ADDENDUM #05
TO
INVITATION TO BID #01

March 26, 2018

WESTERN CONNECTICUT STATE UNIVERSITY
RENOVATIONS TO
HIGGINS HALL & HIGGINS ANNEX

STATE PROJECT NO: BI-RD-290-CMR

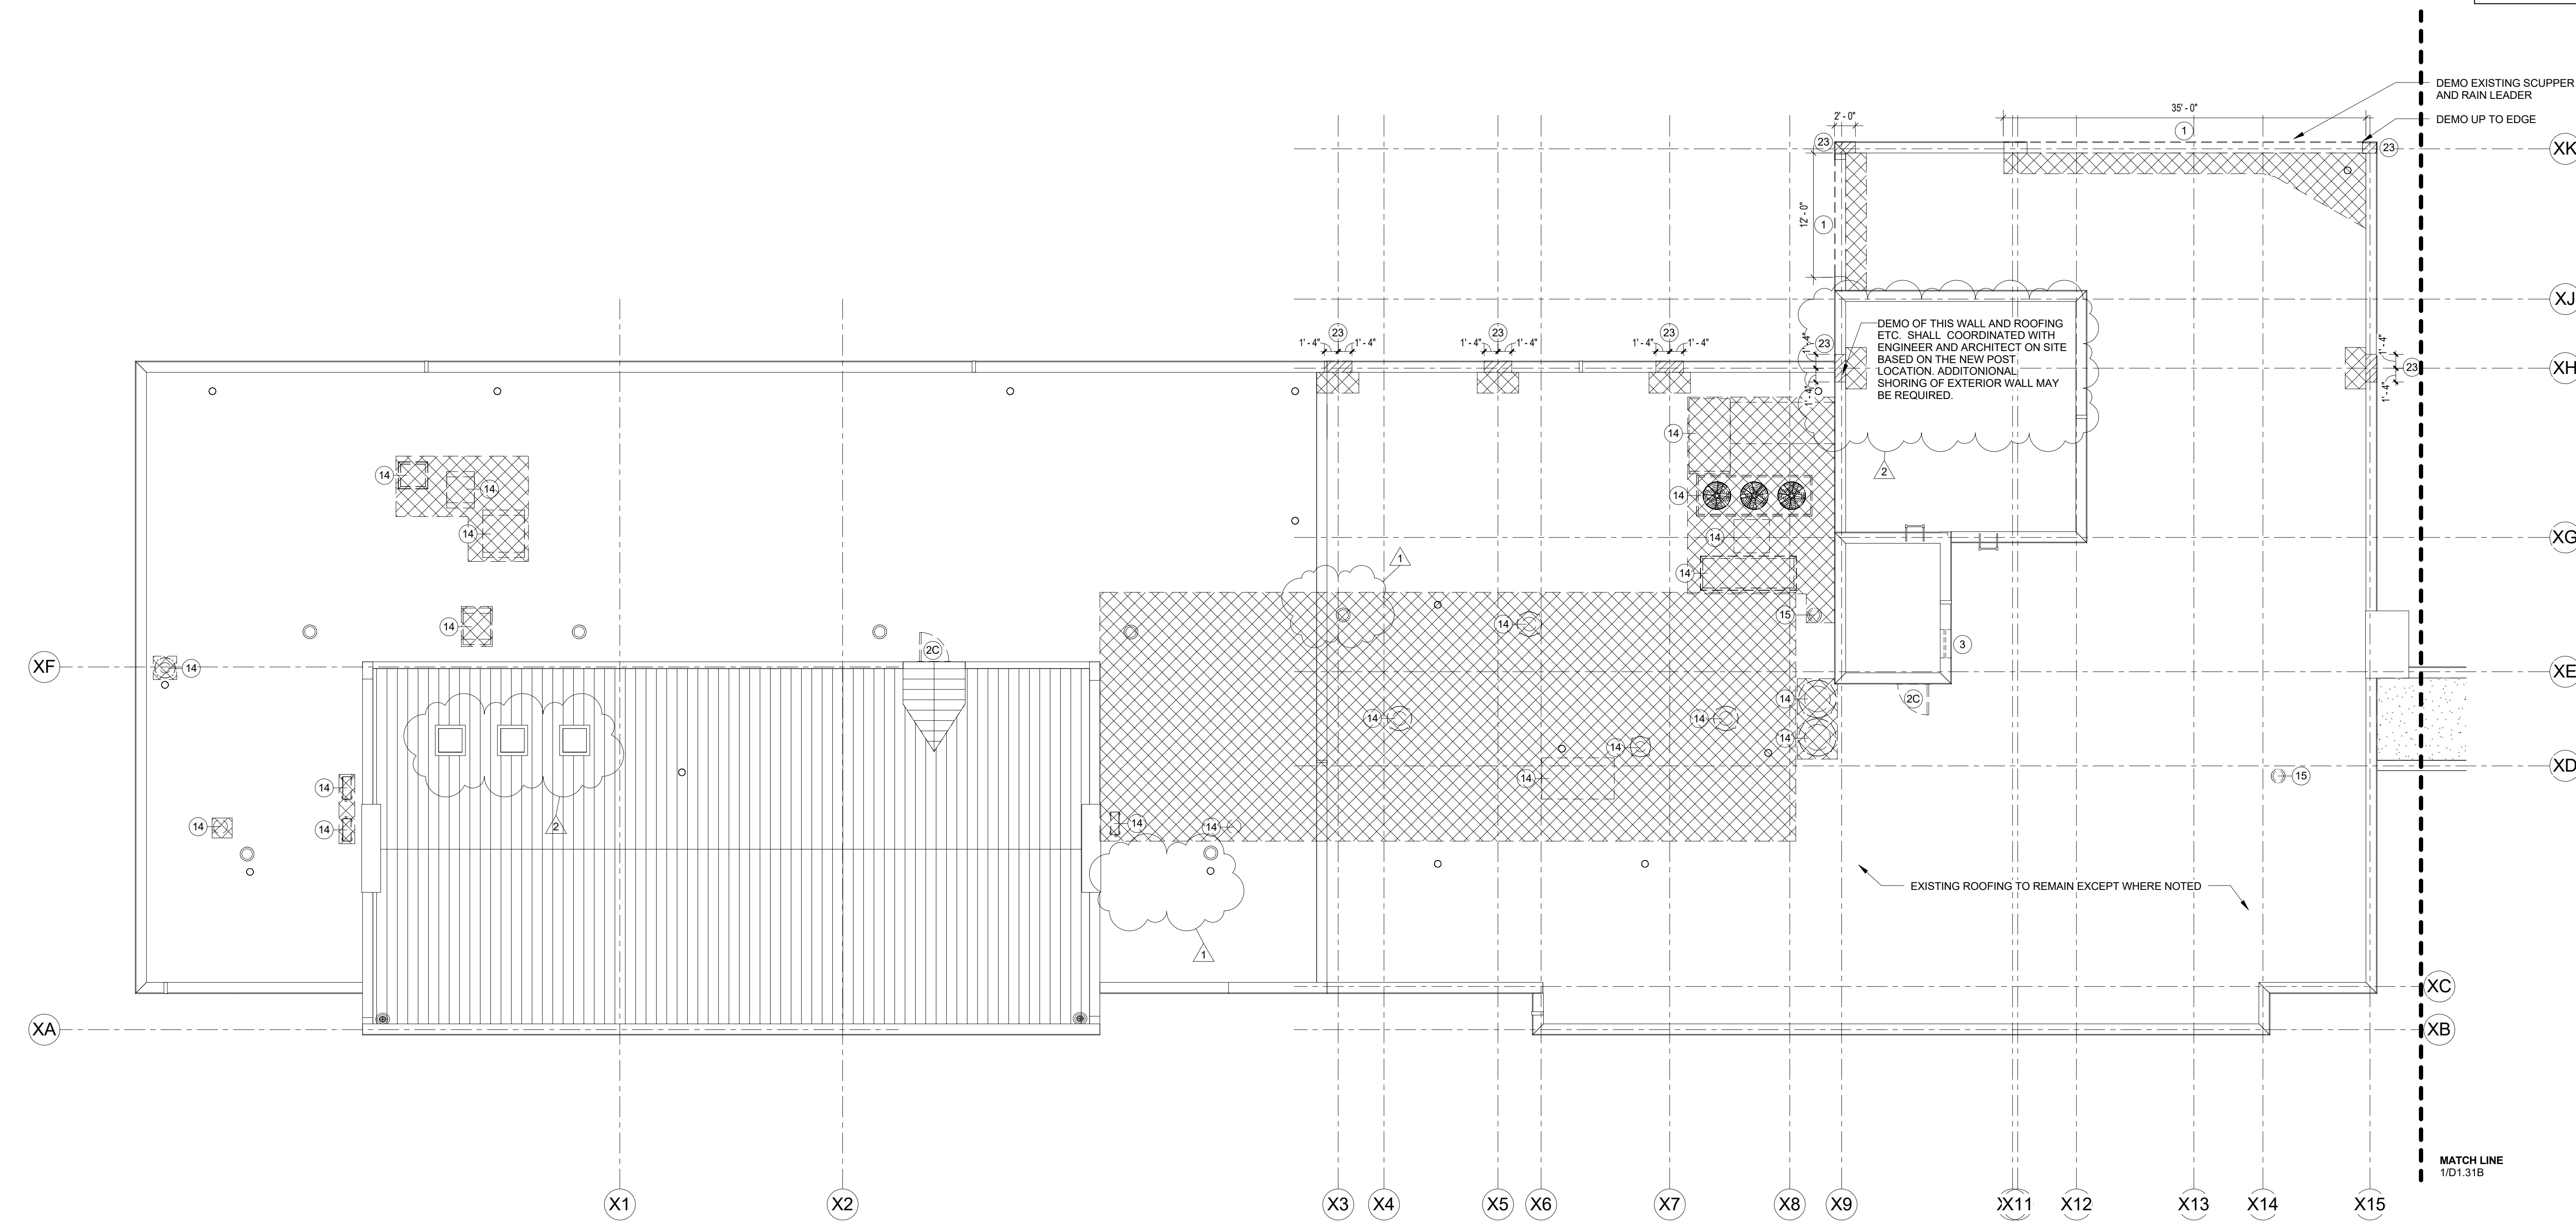
- RFI P** **Question** - Please identify where details 3 & 4/AD1.41 are in reference too? There are no cut

marks on roof plans?

Answer – See revised demo drawing D1.21B showing typical details in TSKP Supplement #3.

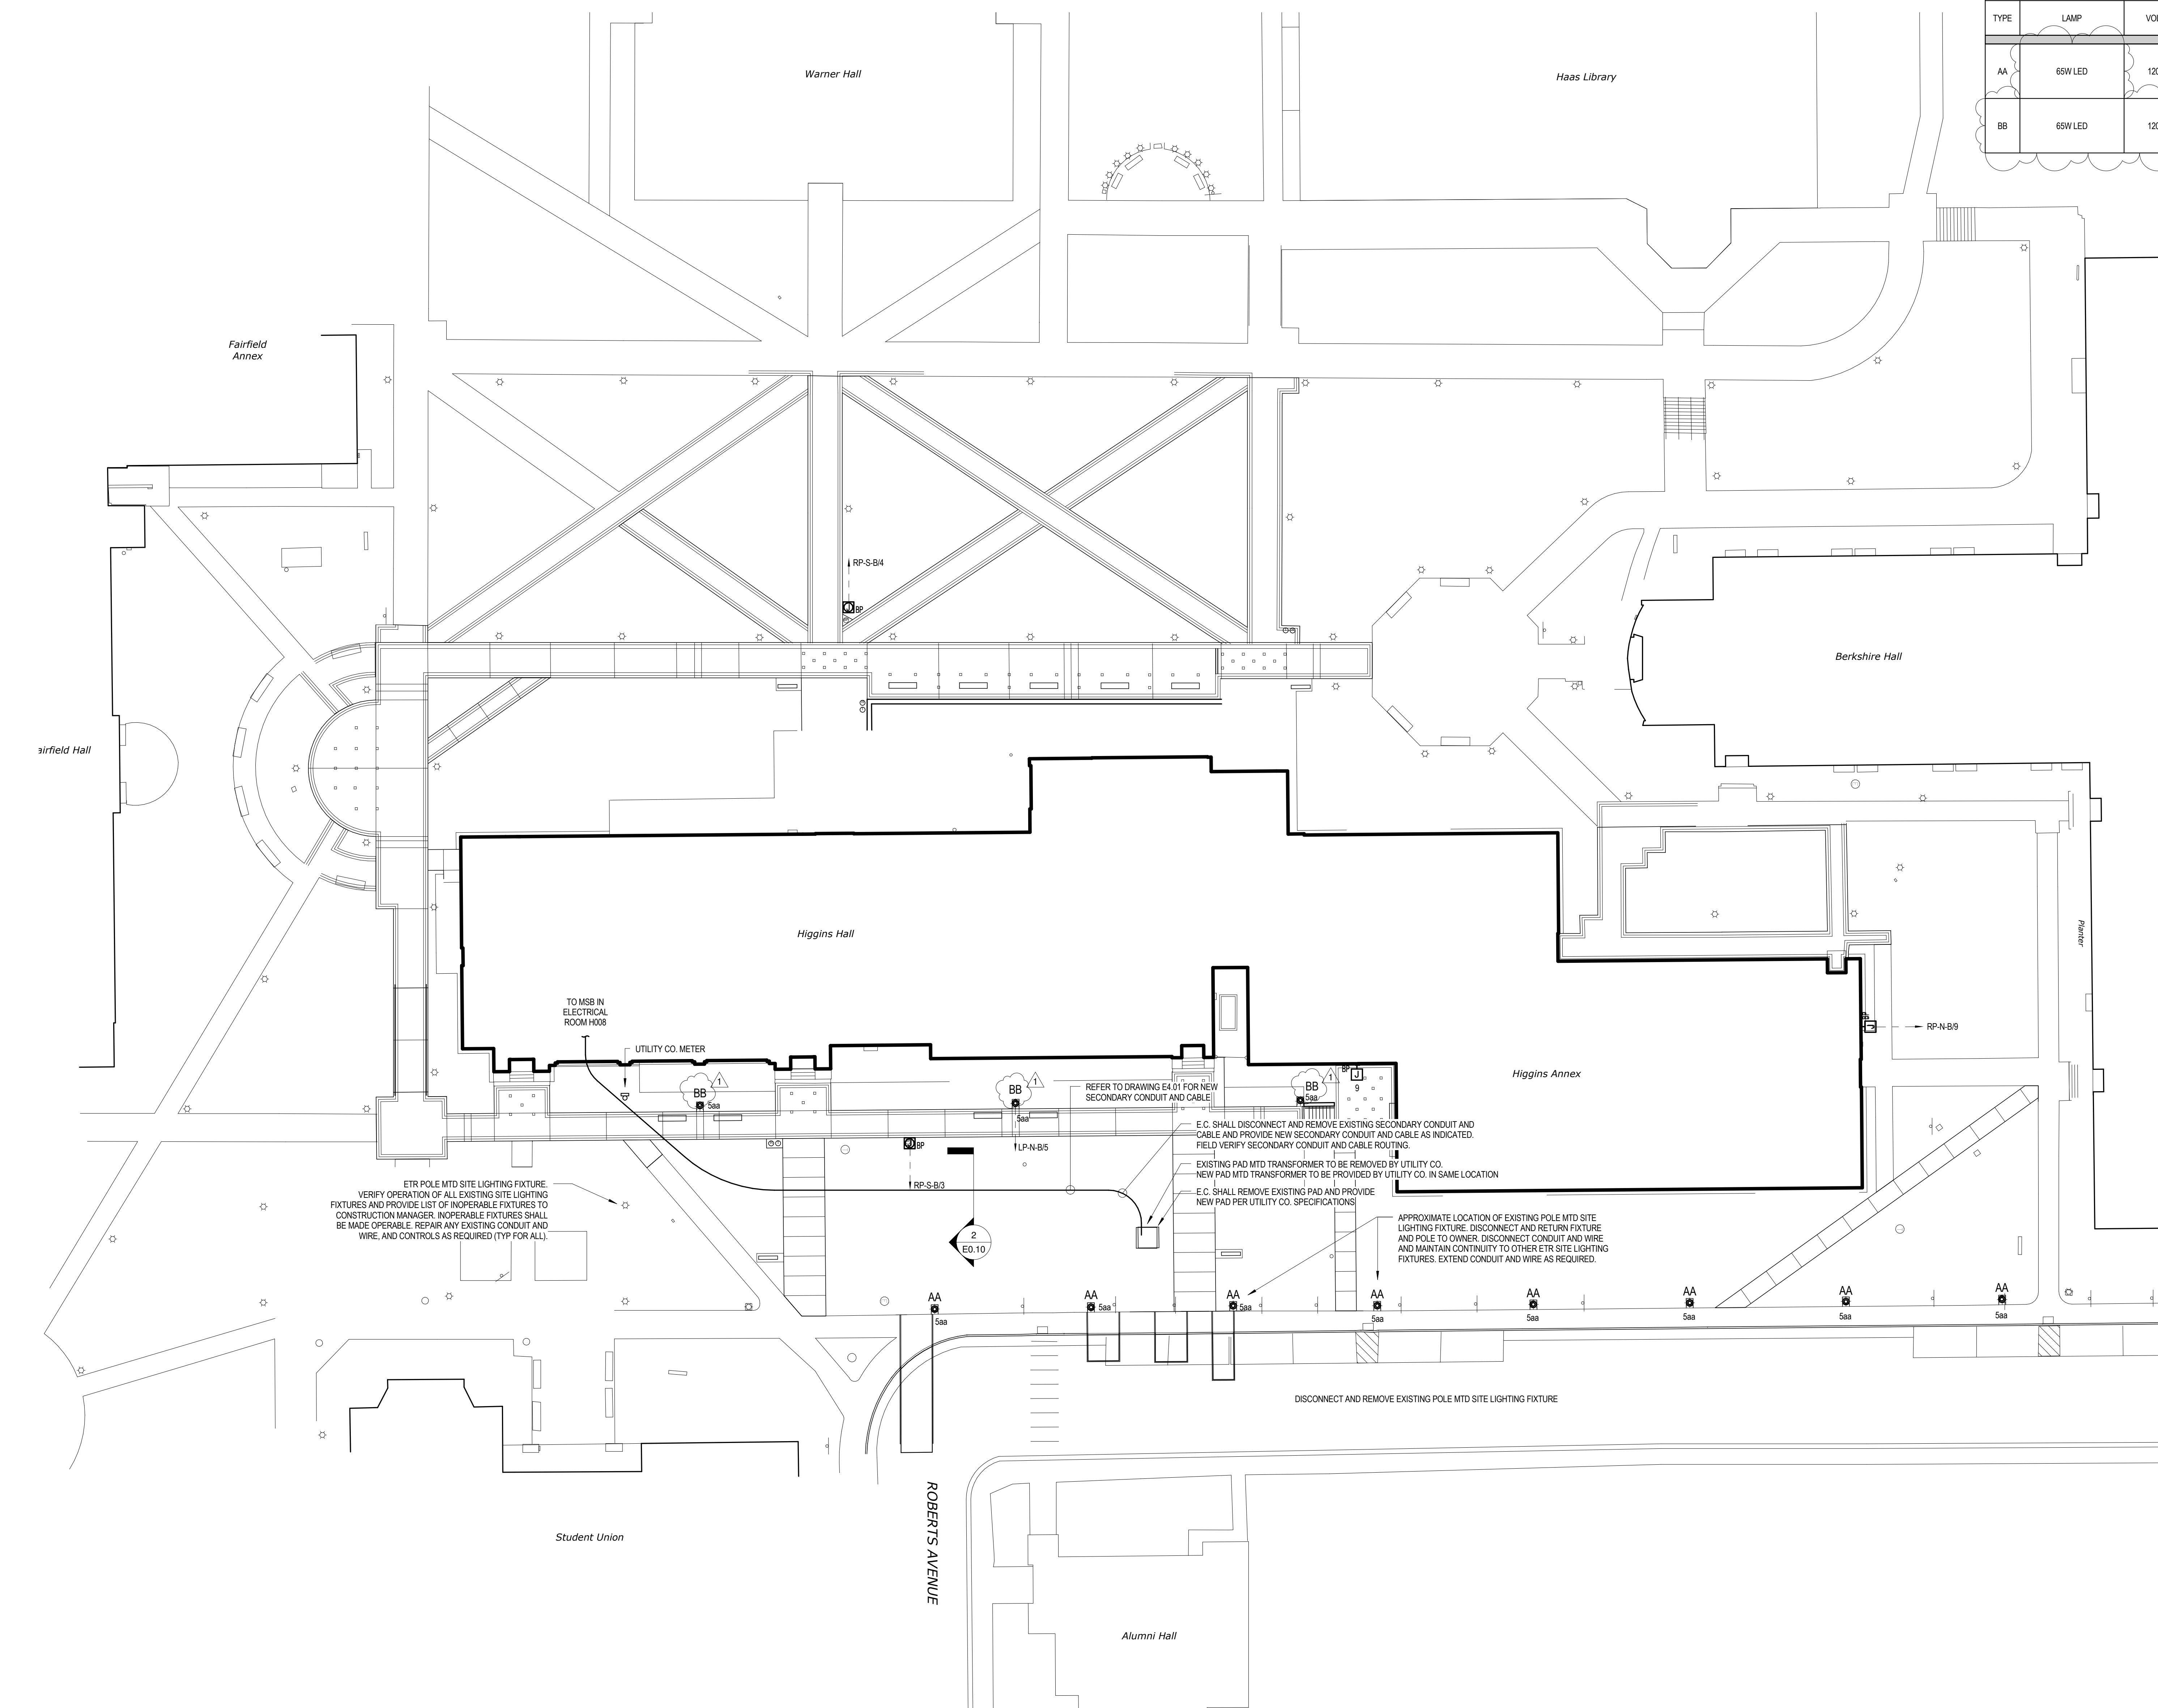
Answer - *Please refer to revised door schedule A11.01 and specification 087100.*
- RFI K** **Question** – Drawing D1.31A calls for 3 curbs to be removed from what looks like a standing seam roof but it doesn't say to patch the roof. Does the roof need to be patched? What is the existing roof manufacturer and color?

Answer - *No detail is required. Existing unit curbs have been abandoned and capped. ETR. Disregard references to the contrary on Drawing A1.31A revised on March 20th per Addendum 4.*
